WATTS BAR NUCLEAR PLANT (WBN) - FINAL SAFETY ANALYSIS REPORT (FSAR)
CHAPTER 12, AMENDMENTS 54 - 63 (TAC NOS. 63647 AND 77061)

WATTS BAR NUCLEAR PLANT (WBN)
RESPONSE TO REQUEST FOR ADDITIONAL INFORMATION (RAI)
CHAPTER 12 UPDATES TO FINAL SAFETY ANALYSIS REPORT (FSAR)
AMENDMENTS 54 THROUGH 63

CHAPTER 12 WATTS BAR FSAR REVIEW
REQUEST FOR ADDITIONAL INFORMATION

FIGURE 12.3-6

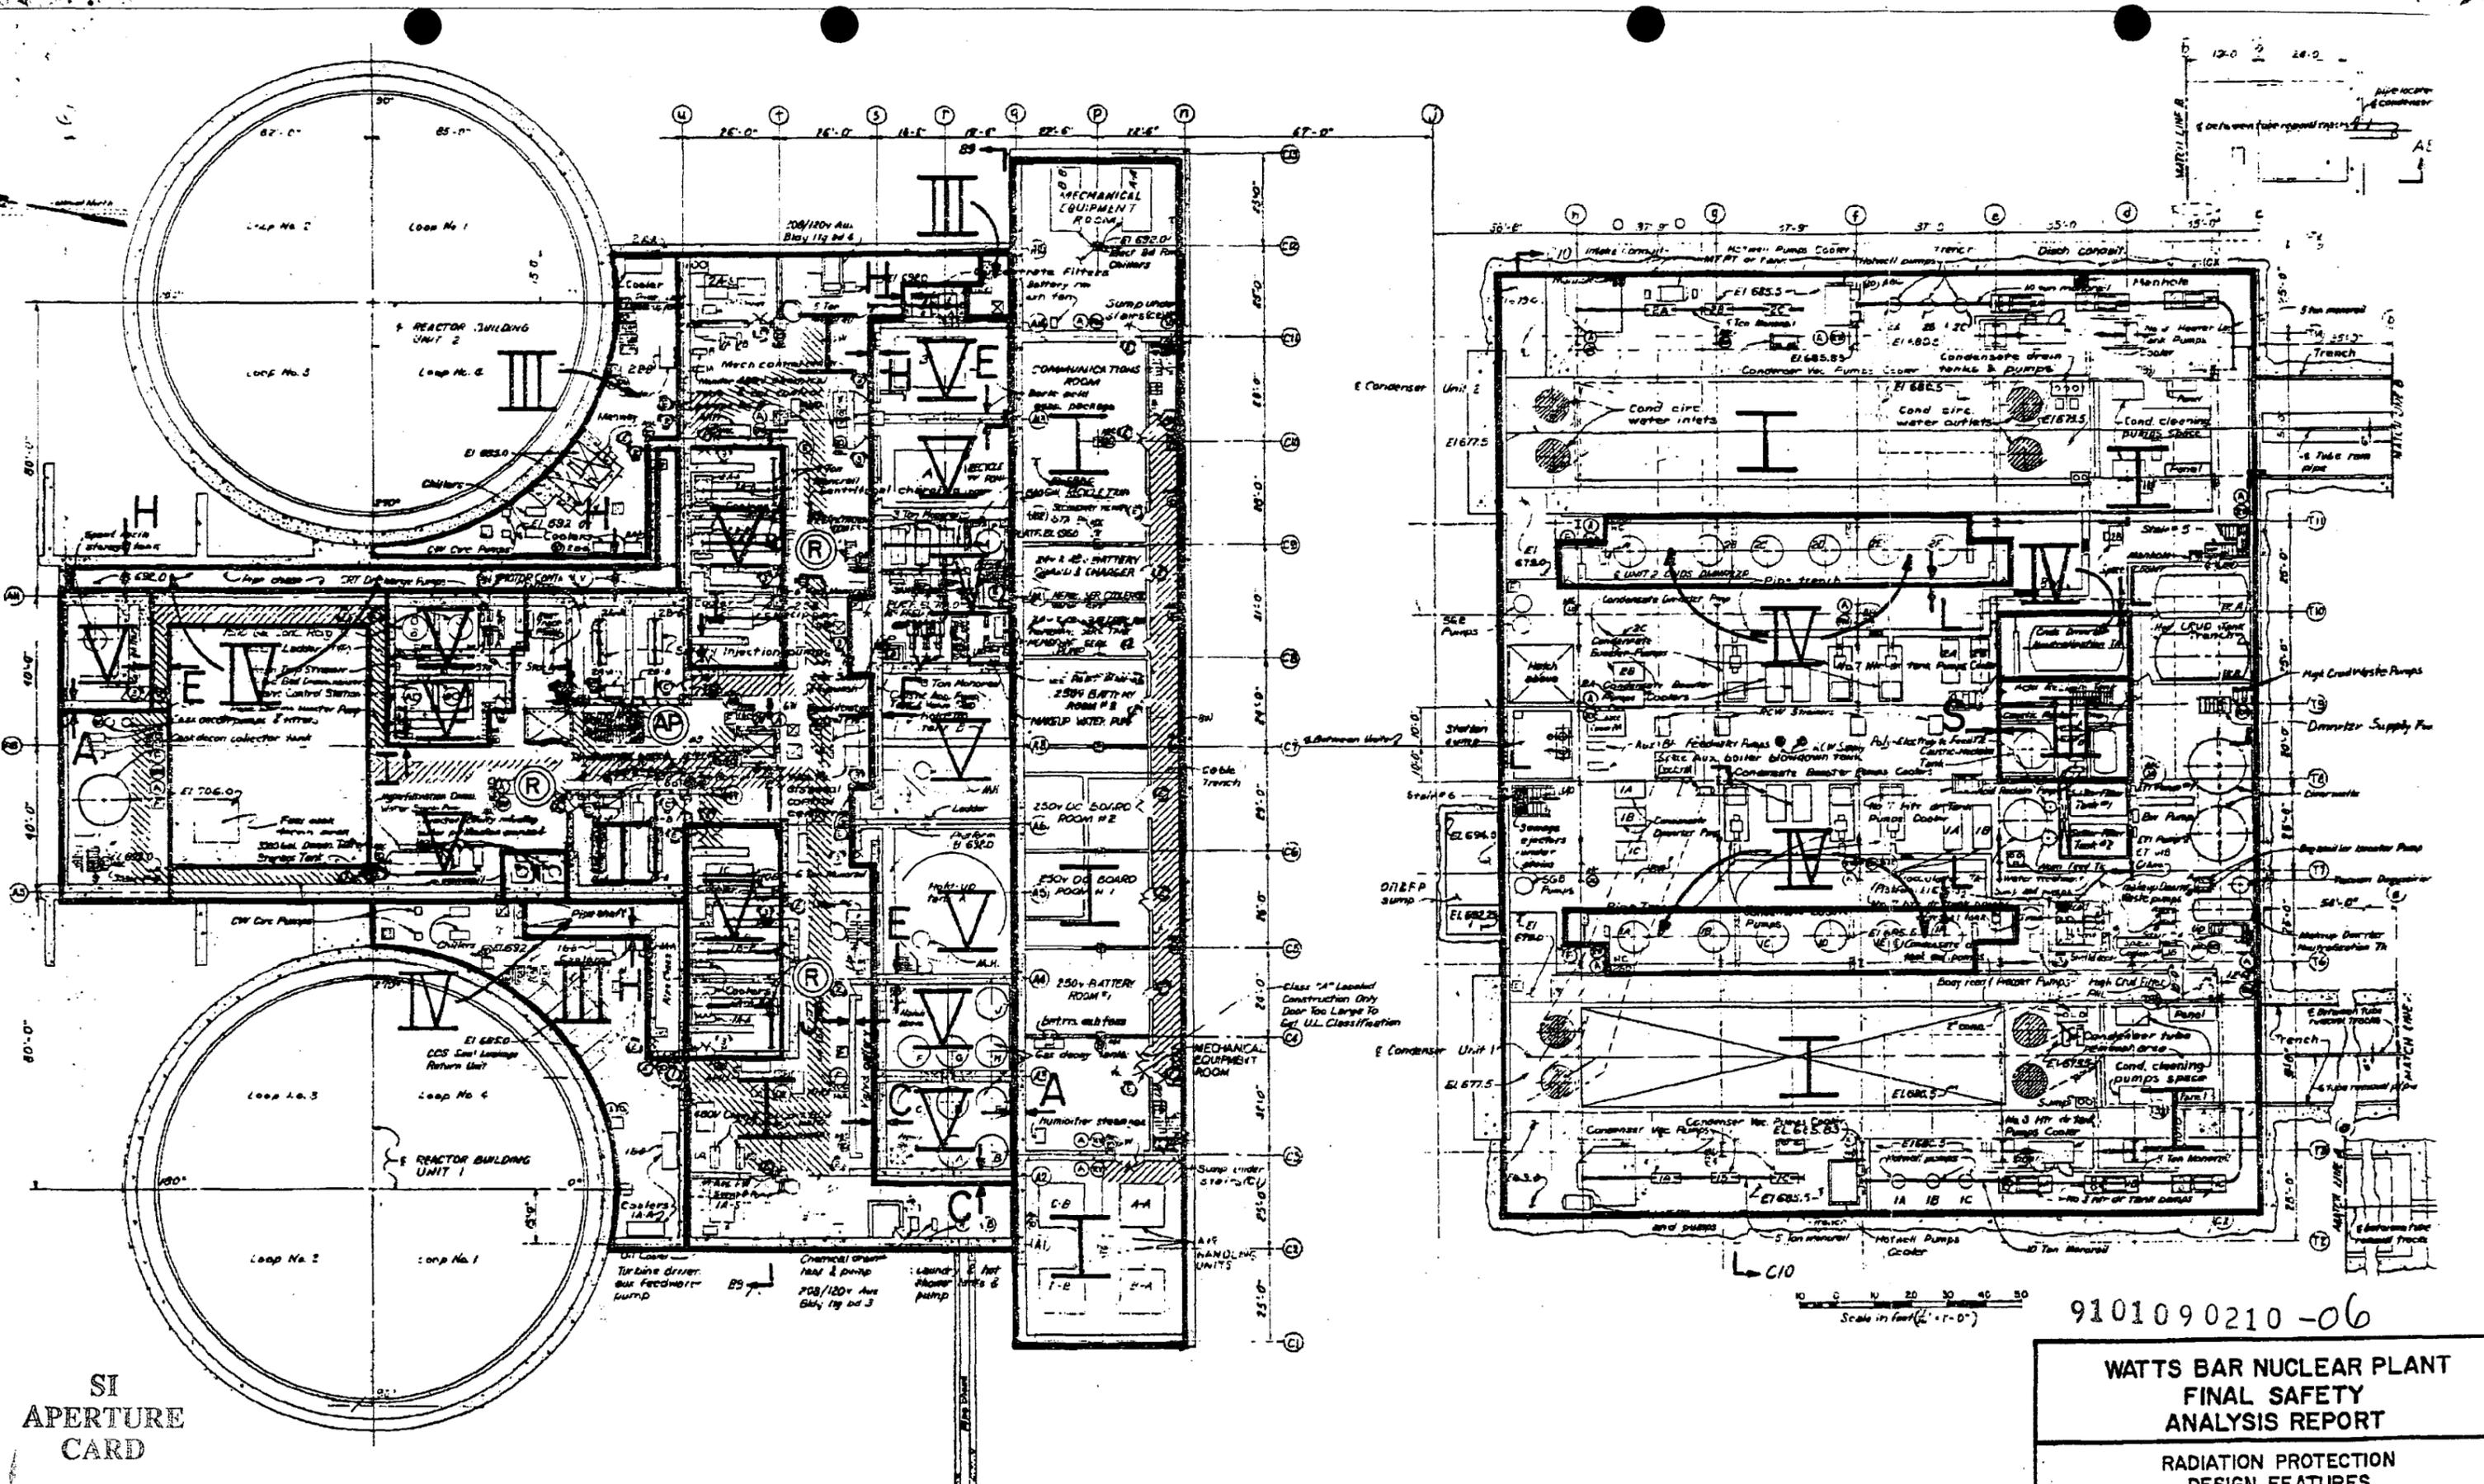
Figures 12.3-5 and 12.3-6 appear to indicate two accessible areas in the auxiliary building adjacent to the spent fuel transfer tube. Figure 12.3-5 shows accessible areas on the 729.0-ft elevation just outside the reactor buildings (near the 270° point). Figure 12.3-6 shows two passageways leading to the cask decon equipment that pass just below the transfer canal (692.0-ft elevation).

Provide an estimate of the peak dose rate in these areas during transfer of "fresh" spent fuel bundles.

Fuel transfer shielding is described in FSAR Section 12.3.2.2, beginning on page 12.3-12 (as of Amendment 64). As stated in this section, 5 ft - 6 in of concrete shielding around the spent fuel transfer canal will reduce the dose rate during fuel transfer to less than 5 mrem/hr in adjacent areas. In the auxiliary building areas on elevations 692.0 ft and 729.0 ft which are adjacent to the fuel transfer canal, there is at least 5 ft - 6 in of concrete shielding around the canal. Accordingly, the dose rate will be less than 5 mrem/hr during spent fuel transfer. The only high radiation area generated by the transfer of spent fuel is in the emergency passageway underneath the transfer canal inside containment where the dose rate could be as high as 210 mrem/hr (see FSAR page 12.3-14). This area is not readily accessible.
